T ECHNICAL INFORMATION

66905

- Subject** ▶ Change of Gear Housing Complete, Gear Housing Cover Complete
- For Models** ▶ DP4700
- Country** ▶ All countries
- Description** ▶ Gear Housing Complete and Gear Housing Cover Complete have been modified as illustrated below.

Gear Housing Complete

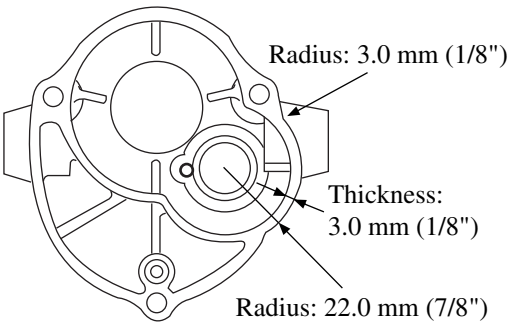
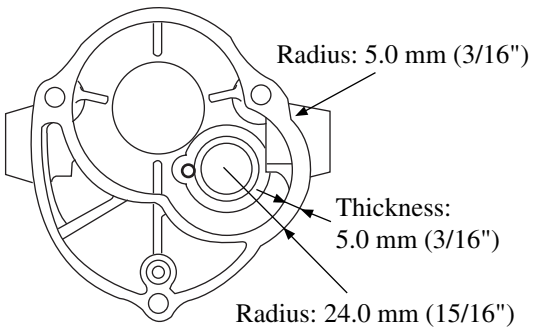
▶ Current	▶ New
 <p>Radius: 3.0 mm (1/8")</p> <p>Thickness: 3.0 mm (1/8")</p> <p>Radius: 22.0 mm (7/8")</p>	 <p>Radius: 5.0 mm (3/16")</p> <p>Thickness: 5.0 mm (3/16")</p> <p>Radius: 24.0 mm (15/16")</p>

Gear Housing Cover Complete

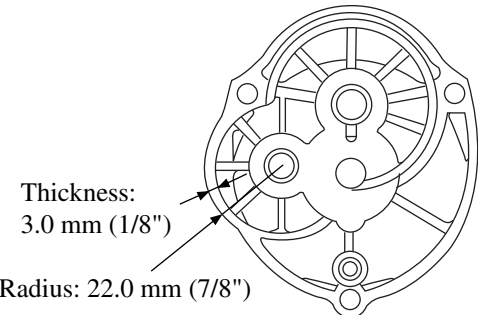
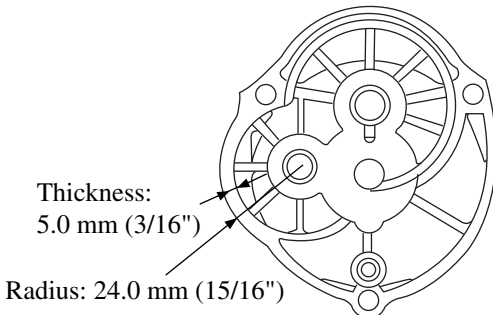
▶ Current	▶ New
 <p>Thickness: 3.0 mm (1/8")</p> <p>Radius: 22.0 mm (7/8")</p>	 <p>Thickness: 5.0 mm (3/16")</p> <p>Radius: 24.0 mm (15/16")</p>
